Mountain Ridge Estates

Coventry, Connecticut

Review Date: *AUGUST 13, 1987*

ENVIRONMENTAL REVIEW TEAM REPORT
ON
MOUNTAIN RIDGE ESTATES SUBDIVISION
COVENTRY, CONNECTICUT

d. Road layout.

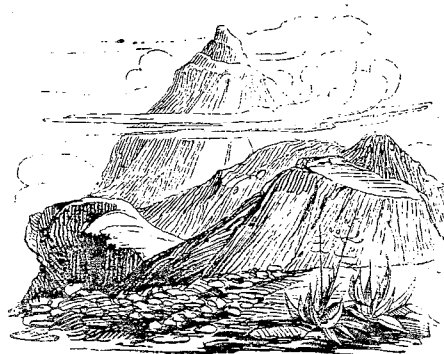
Maximum cul-de-sac length is limited to 650 feet by Coventry's subdivision regulations. The temporary Timber Trail cul-de-sac exceeds that length while the preliminary plan indicates future road connections through adjoining properties.

The Section 1 plan provides no indication of future development, again pointing out the need for overall development plans.

Maximum cul-de-sac length is recommended by the State of Connecticut, Department of Transportation, "Guidelines for Subdivision Streets" to be 1000 feet or no more than 20 house lots, providing for a maximum of 200 vehicle trips per day (assuming 10 trips per day per single unit dwelling).

Sections of the proposed road indicate grades as steep as 12%, which is permitted under Coventry's regulations.

State and national guidelines, however, recommend a maximum grade of 10%. Grades up to 12% are to be considered only on short sections of streets in hilly terrain.
